Work Order ID 159272

Item Name: Replacement Skidtube (Fits LH or RH)

DRAWING NO. D2650	TITLE 206/407 SKIDTUBE ASSEMBLIES	REV. F	DART AEROSPACE LTD ENGINEERING ORDER		D.E.O. NO. D2650-F-1	SHEET NO. SHEET 1 OF 1	SCALE NTS
DRAWN <i>[Signature]</i>	CHECKED A.P.	MFG. APPR. <i>[Signature]</i>	APPROVED <i>[Signature]</i>		DE APPR. <i>[Signature]</i>		
DATE 12.10.12	DATE 12.10.22	DATE 12.10.22	DATE 12.10.22		DATE 12.10.22

CHANGE C'BORED WELDED CROSSBOLT SPACERS TO SWAGED SPACERS

DETAIL G

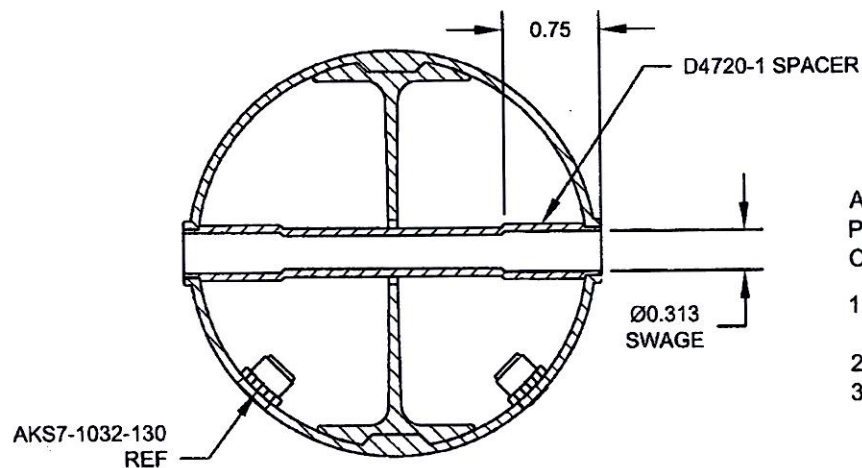
ADD DETAIL G BELOW, WHICH IS THE SAME SECTION VIEW AS DETAIL D OF DWG.
C'BORED HOLES ARE **NOW SWAGED** PER DETAIL G BELOW. FOR THE Ø0.375 HOLE THAT IS NOT C'BORED, WELD PER DETAIL D OF DWG (SEE AMENDED DETAIL B FOR REFERENCE).

FOR Ø0.375 HOLES ONLY

DETAIL B

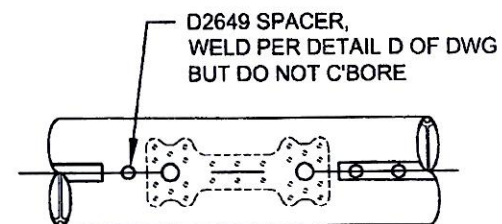
FOR HOLES THAT ARE CURRENTLY C'BORED ONLY
NOT TO SCALE

D2649 SPACER,
WELD PER DETAIL D OF DWG
BUT DO NOT C'BORE

AMENDMENT TO DETAIL B
NOT TO SCALE
